SAFETY EVALUATION REPORT  
BY THE  
DIRECTORATE OF LICENSING  
U.S. ATOMIC ENERGY COMMISSION  
IN THE MATTER OF  
ARKANSAS POWER & LIGHT COMPANY  
ARKANSAS NUCLEAR ONE - UNIT 1 PLANT  
DOCKET NO. 50-313

DEC 27 1974

ARKANSAS POWER & LIGHT CO. ARKANSAS NUCLEAR ONE-UNIT 1	LOCA LIMITED MAXIMUM ALLOWABLE LINEAR HEAT RATE	FIG. NO. 3.5.2-4
---	--	---------------------

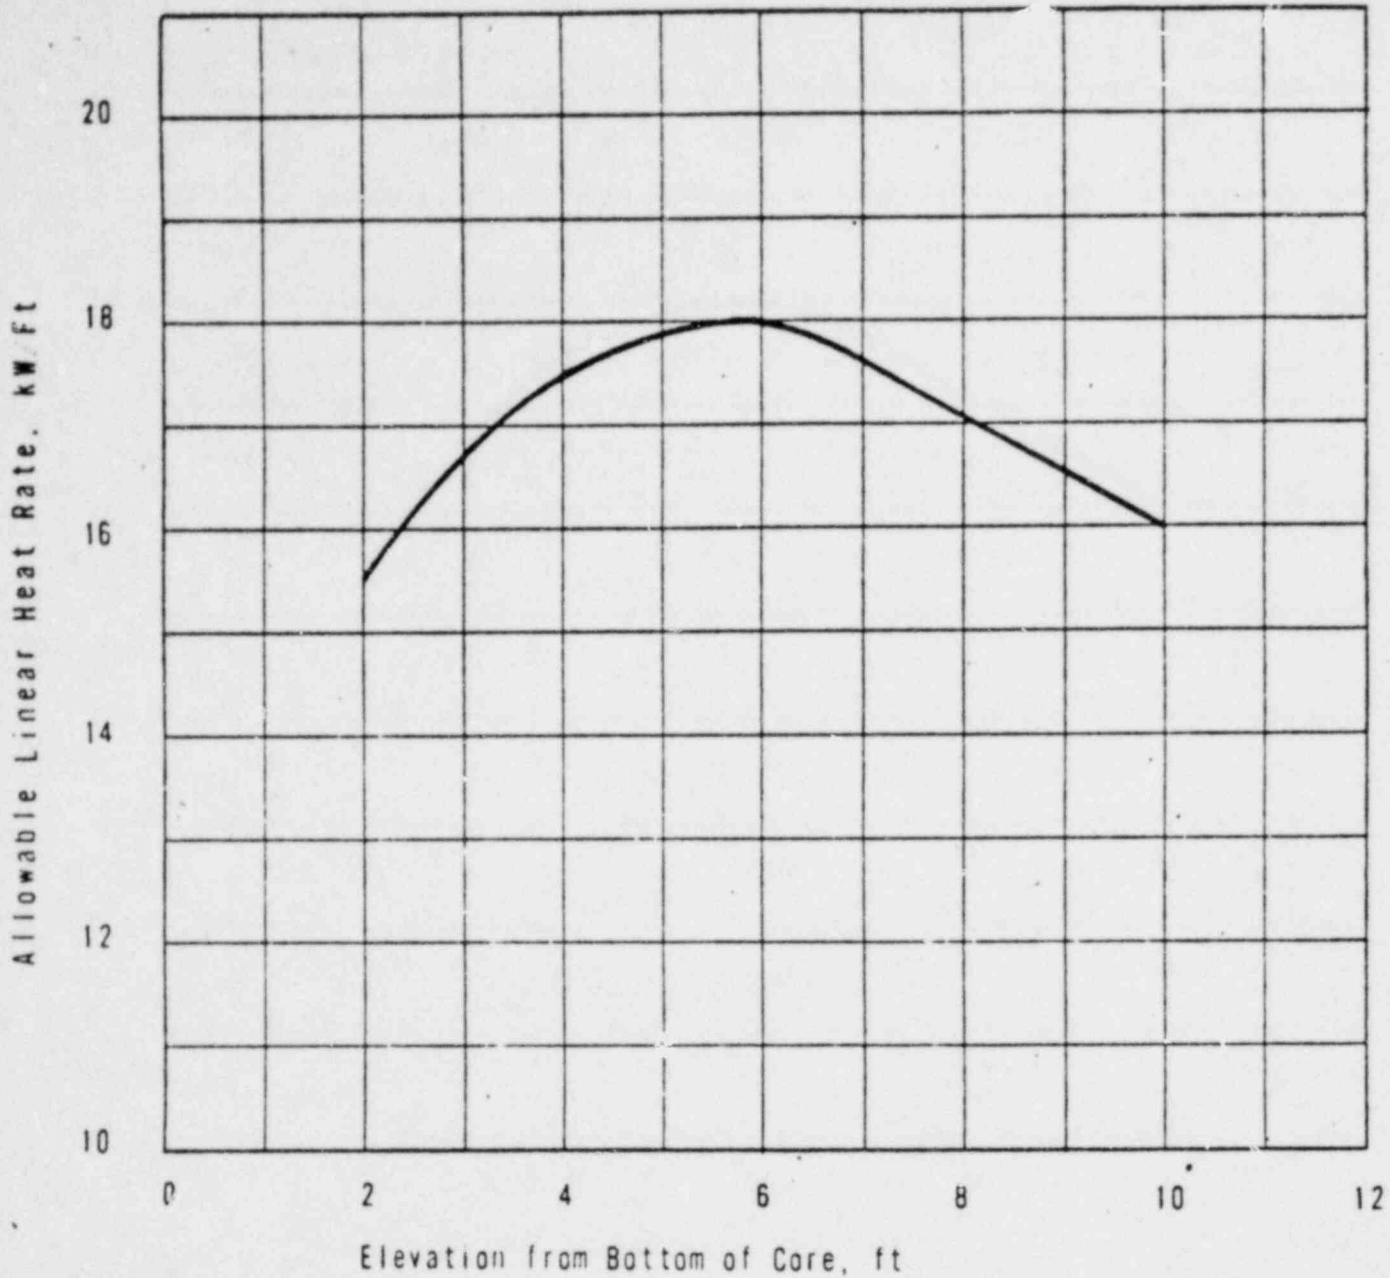
A review of preceding Sections 4.1 through 4.5 shows that the two model deficiencies which have an impact on the previous generic calculations are region nodding (Section 4.3) and vent valve K-factor (Section 4.5). Table 2 shows a summary of the results of sensitivity studies by Babcock and Wilcox on peak clad temperature, local metal-water reaction, and whole core metal-water reaction. These calculations indicate that, while the model corrections could cause an increase in peak clad temperature, this increase would not be large enough to exceed the criteria of 10 CFR 50.46, provided that the LOCA limit curves submitted in the licensee's proposed Technical Specifications are observed in facility operation. These curves are set forth in Appendix A.

Based on the analysis set forth in this Safety Evaluation, the limitations contained in the licensee's submittals, particularly the LOCA limit curve set forth in Appendix A, will assure conformance with the peak clad temperature limit, and maximum oxidation and

hydrogen generation criteria of 10 CFR 50.46(b). However, these restrictions should be verified by a re-analysis based on the Babcock and Wilcox Evaluation Model, modified as described in this Safety Evaluation Report.
